Well Name: JAMES RANCH UNIT DI 7 SAWTOOTH	Well Location: T23S / R31E / SEC 6 / LOT 3 /	County or Parish/State:
Well Number: 905H	Type of Well: CONVENTIONAL GAS WELL	Allottee or Tribe Name:
Lease Number: NMNM02953C	Unit or CA Name: JAMES RANCH	Unit or CA Number: NMNM070965Z
US Well Number:	Well Status: Approved Application for Permit to Drill	Operator: XTO PERMIAN OPERATING LLC

Type of Submission: Notice of Intent

Type of Action: APD Change

Procedure Description: XTO Permian Operating LLC respectfully requests a change to the wellbore location that will include the following changes: Surface Hole Change, First and Last Take Point. SHL: FROM: 155' FNL & 2368' FWL TO: 155' FNL & 2368' FWL of Section 6-T23S-R31E FTP: FROM: 700' FSL & 2530' FWL TO: 330' FNL & 1870' FEL of Section 6-T23S-R31E PPP1: 2637' FNL & 1873' FEL PPP2: 0' FNL & 1877' FEL LTP: FROM: 2541' FNL & 2530' FWL TO: 2540' FNL & 1870' FEL of Section 18-T23S-R31E BHL: FROM: 2590' FNL & 2530' FWL TO: 2590' FNL & 1870' FEL of Section 18-T23S-R31E, proposed total depth and formation (pool) will also change. Proposed TD: FROM: 25,339' MD; 11,160' TVD (Los Medanos (Wolfcamp) South) TO: 22,484' MD; 9,853' TVD (Los Medanos; Bone

WELL LOCATION AND ACREAGE DEDICATION PLAT

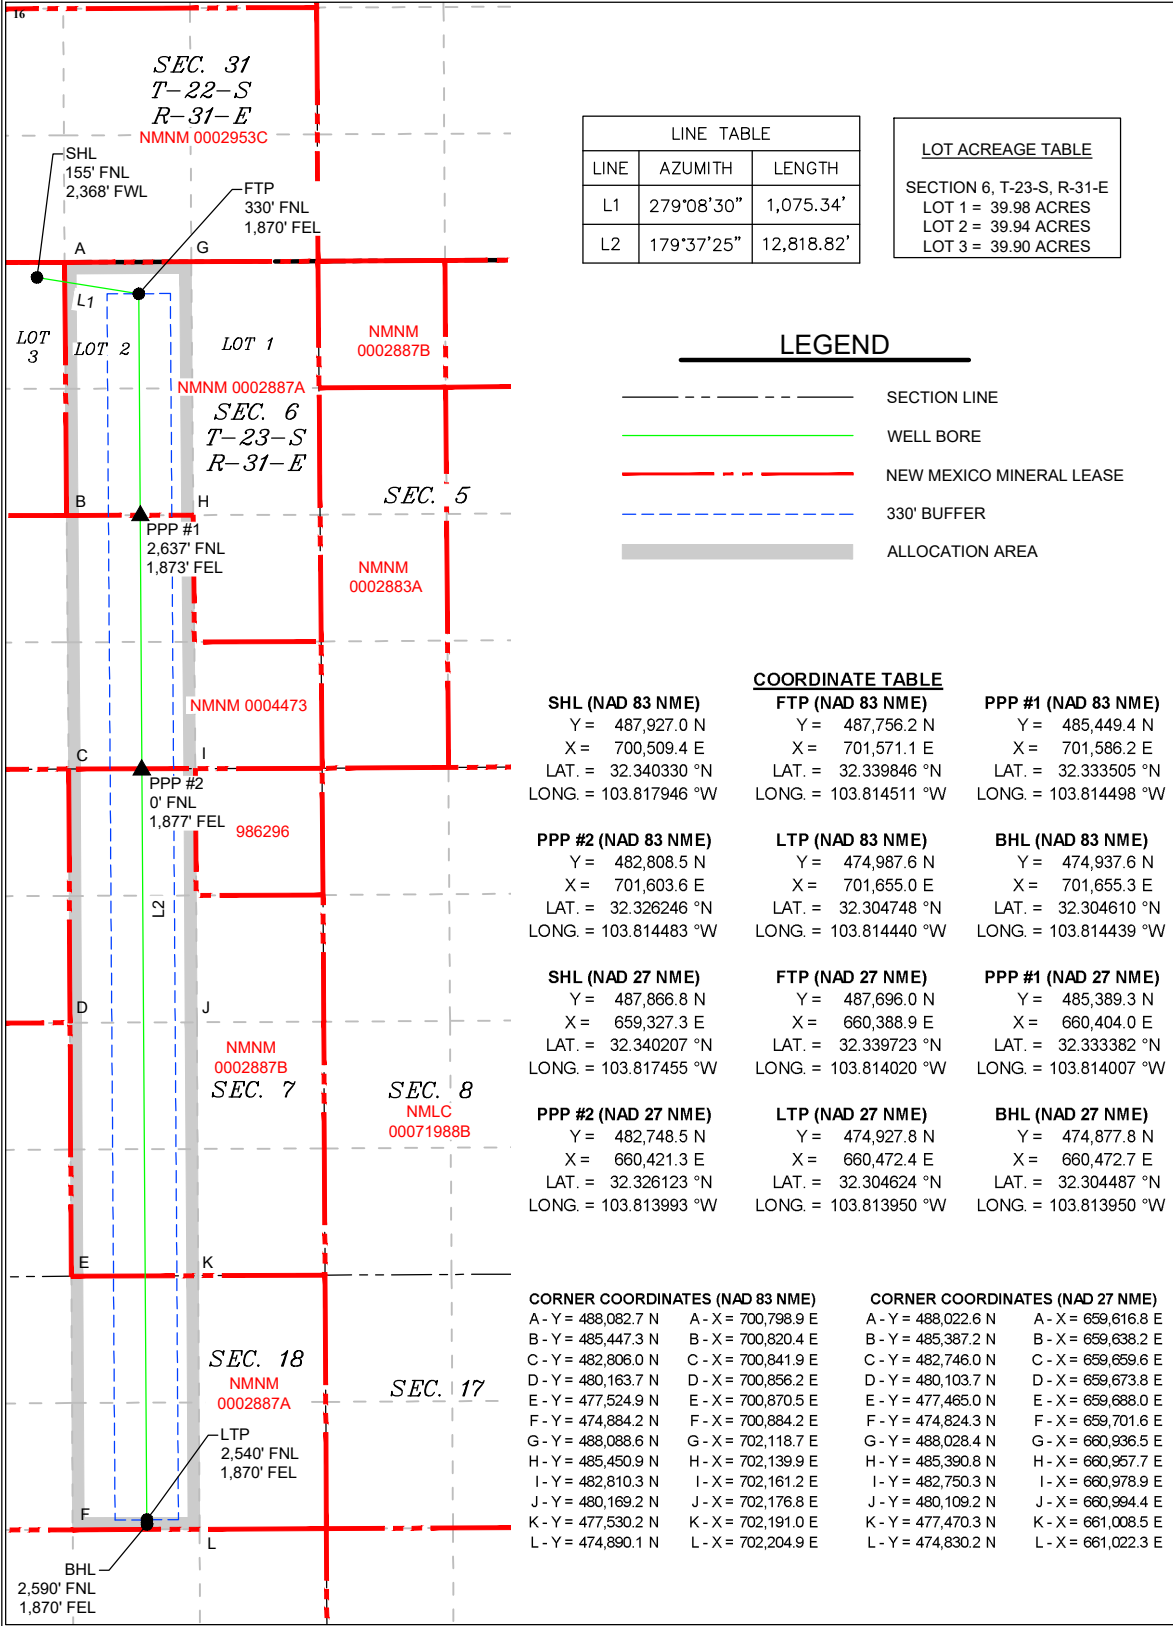
XTO Permian Operating LLC respectfully requests a change to the wellbore location that will include the following changes: Surface Hole Change, First and Last Take Point, Bottom Hole, proposed total depth and formation (pool).

SHL: FROM: 155 FNL & 2368 FWL TO: 155 FNL & 2368 FWL of Section 6-T23S-R31E
FTP: FROM: 700 FSL & 2530 FWL TO: 330 FNL & 1870 FEL of Section 6-T23S-R31E
PPP1: 2637 FNL & 1873 FEL
PPP2: 0 FNL & 1877 FEL
LTP: FROM: 2541 FNL & 2530 FWL TO: 2540 FNL & 1870 FEL of Section 18-T23S-R31E
BHL: FROM: 2590 FNL & 2530 FWL TO: 2590 FNL & 1870 FEL of Section 18-T23S-R31E
Proposed TD: FROM: 25,339' MD; 11,160' TVD (Los Medanos (Wolfcamp) South) TO: 22,484' MD; 9,853' TVD (Los Medanos; Bone Spring)
